CONSTRUCTION AUTHORIZATION FOR AN ON-SITE WASTEWATER TREATMENT & DISPOSAL SYSTEM

MECKLENBURG COUNTY
GROUNDWATER & WASTEWATER SERVICES

FILE NUMBER: 10219B

ADDRESS: 3930 WELL RD

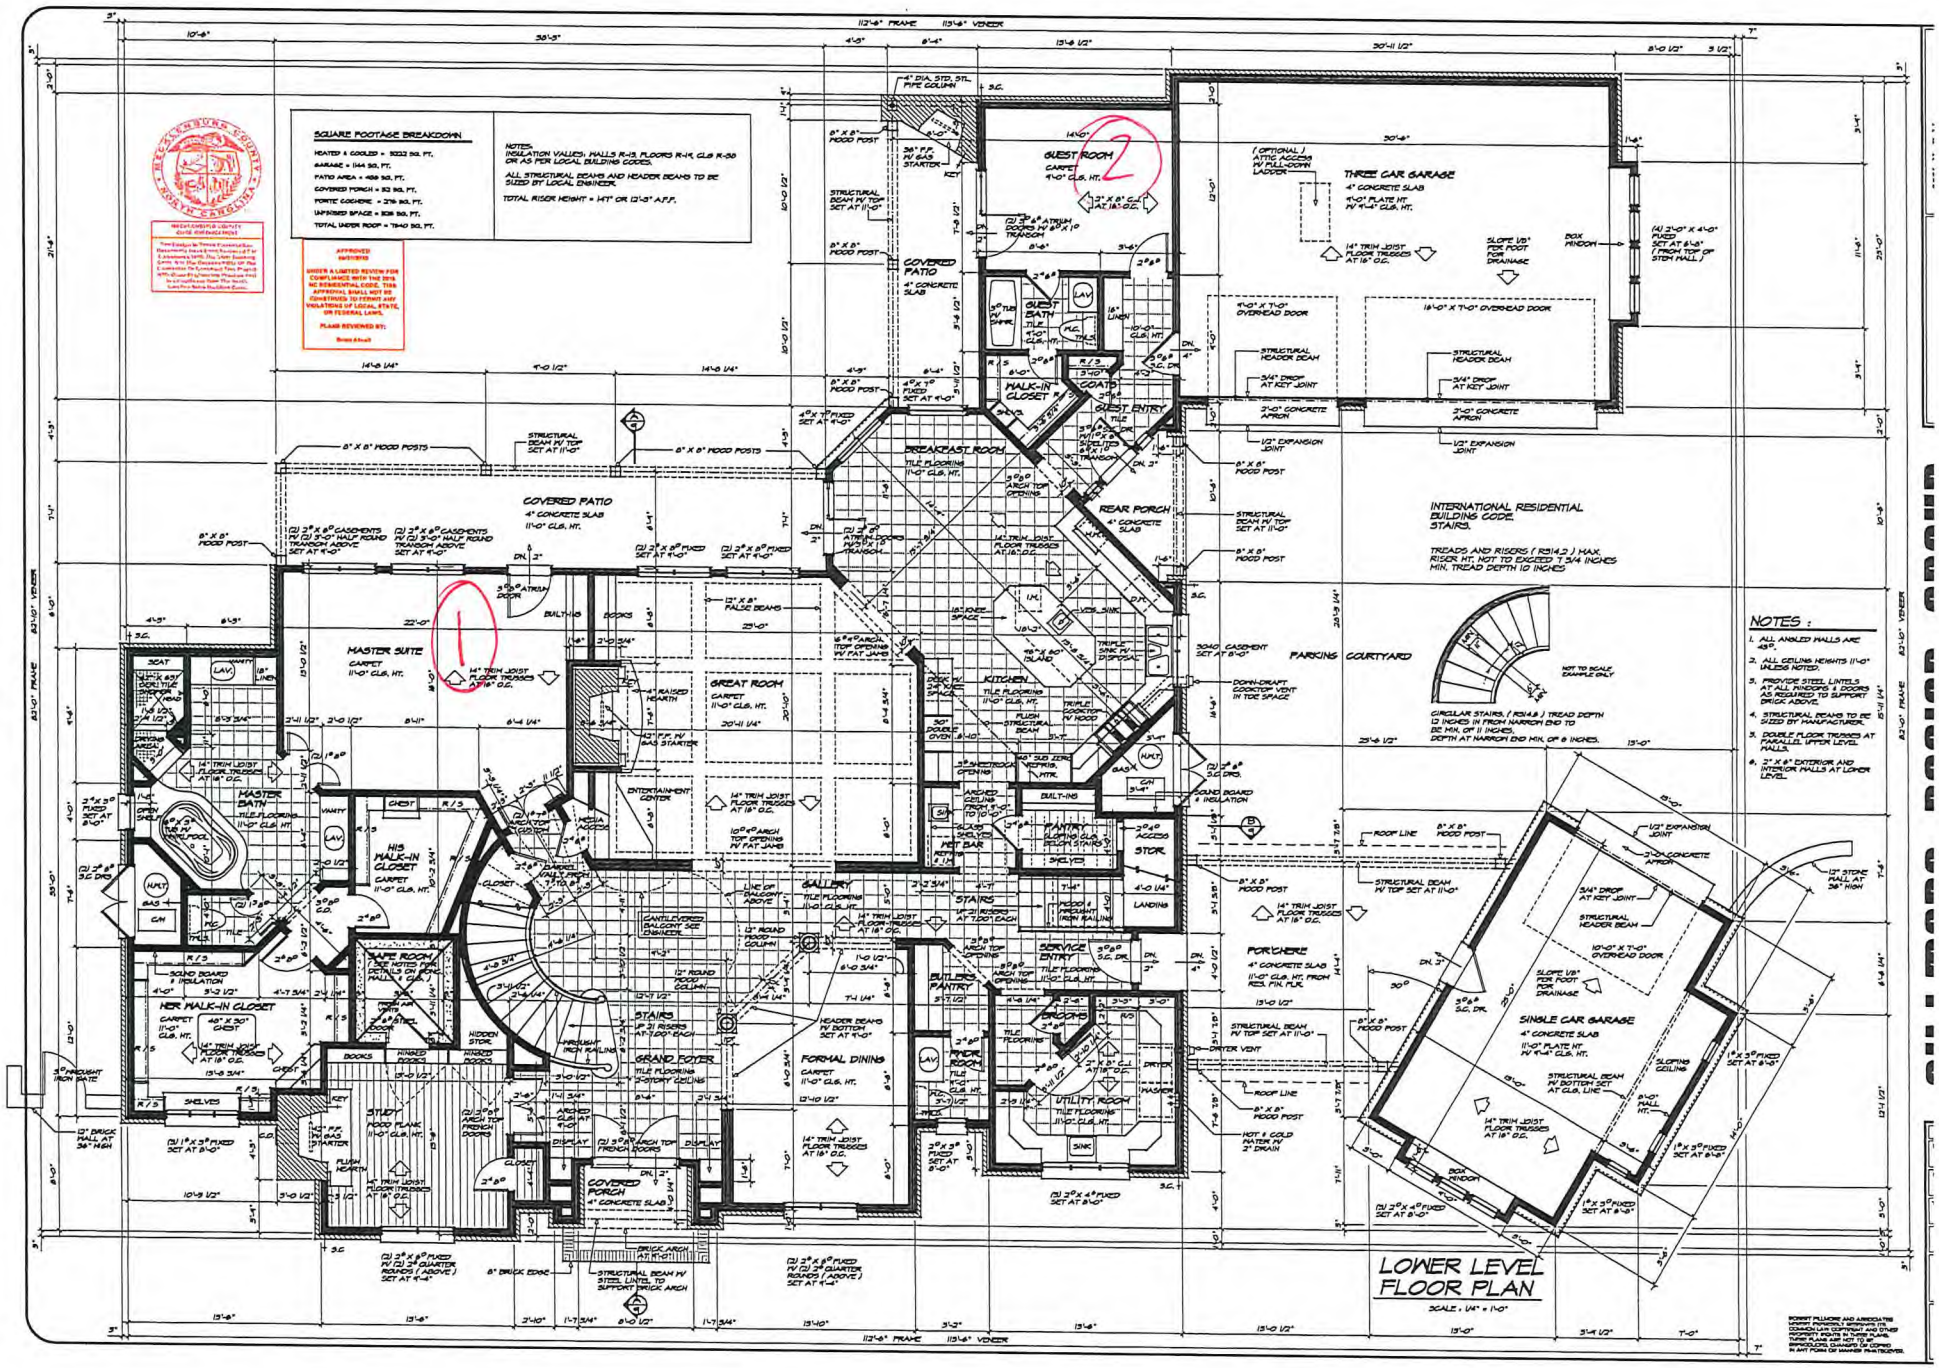
Floor plans need to be submitted and reviewed before CA can be issued ☒ Review ☒ 9/9/20 - Closet will be Removed in the Media Room

MEDIA Room
Meets the definition
of a bedroom
Closet needs to
be removed
UPPER LEVEL
FLOOR PLAN
SCALE : 1/4" = 1'-0"
BEDROOM # 5
BEDROOM # 3
BEDROOM # 4
BEDROOM # 2
MEDIA ROOM
GAME STOR.
GRAND FOYER BELOW
ATTIC STORAGE
FUTURE BRIDGE
FUTURE BONUS ROOM
STAIRS
BALCONY
WALK-IN CLOSET
BATH # 3
BATH # 4
HALF BATH
LINEN
LAUNDRY
LANDING
SLOPING CEILING
LOWER LEVEL VENEER LINE
BRICK CHIMNEY
STONE CHIMNEY
83'-3" OVERALL
4'-0" FRAME
4'-3" VENEER
